15 May 2018

WSP Opus

Ref: 5-G2858.01

REQUEST FOR FURTHER INFORMATION - RESOURCE CONSENTS RM175439-441; RM185003-5; RM185013-15

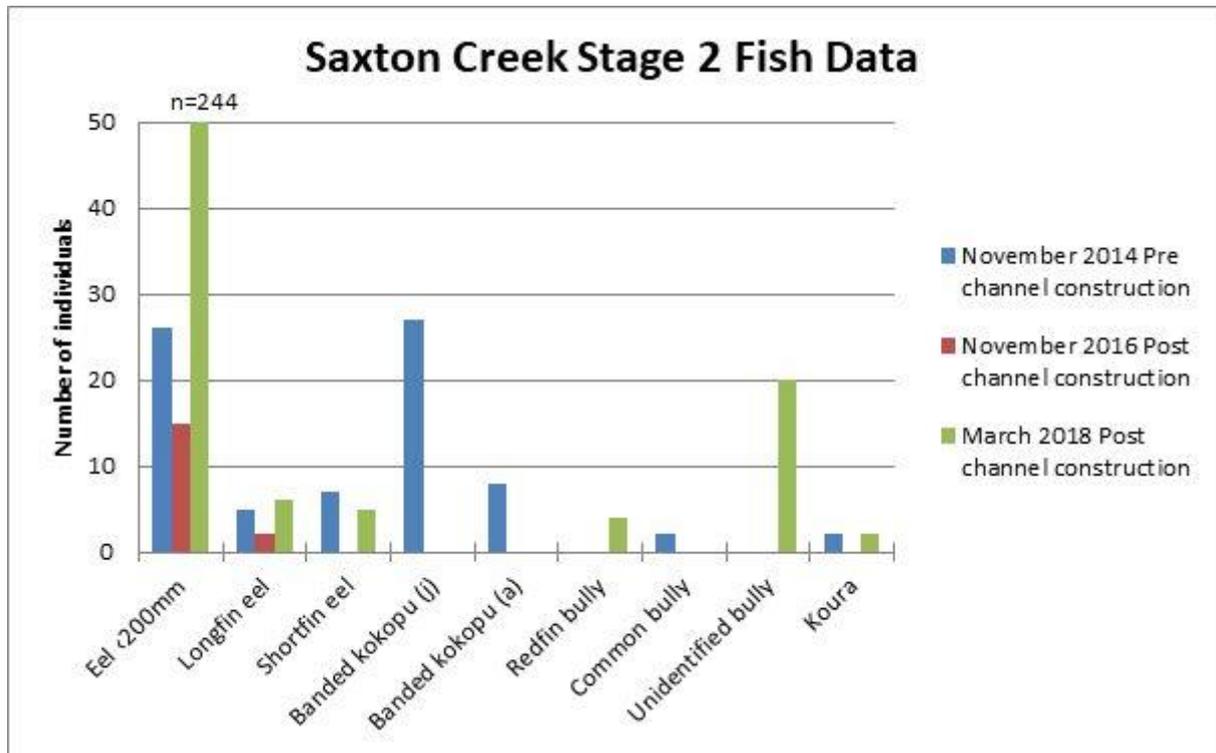
Since the completion of Stage 2 and Stage 1, the Saxton Creek environment has undergone significant changes. Fish passage barriers have been removed repaired and improved, providing for migration opportunities from the sea to the uplands. Construction of a gravel trap in Stage 2 will prevent extensive downstream accumulations, reducing flood risks and habitat destruction. Channel widening will also reduce the devastating effects of flooding in Saxton Creek. Increasing the water storage capacity of the former Daelyn's irrigation dam (Saxton Pond) and diverting Saxton Creek through the pond provides habitat opportunities for migrating and resident fish. Eventually new plantings will provide improved spawning areas for inanga and bank stabilisation. Some planted areas will remove overland sediment discharge and provide stream shading. Willow trees along with their root mats and the invasive pampas grass has been removed, and more will be as part of the Stage 3 works. Stock access to Saxton Creek has now been excluded.

The use of rock, both within the channel and banks in Stages 2 and 1, will increase the water temperatures of Saxton Creek during the summer months until planted vegetation is established. The use of geotextile cloth on the stream bed will reduce the hyporheic habitat until such time that bed material mobilises and settles from upstream sources. With the exceptions of Saxton Pond and the gravel trap large pool habitat has been lost. Stream shading by invasive plantings, introduced and native plants has been lost to channel widening.
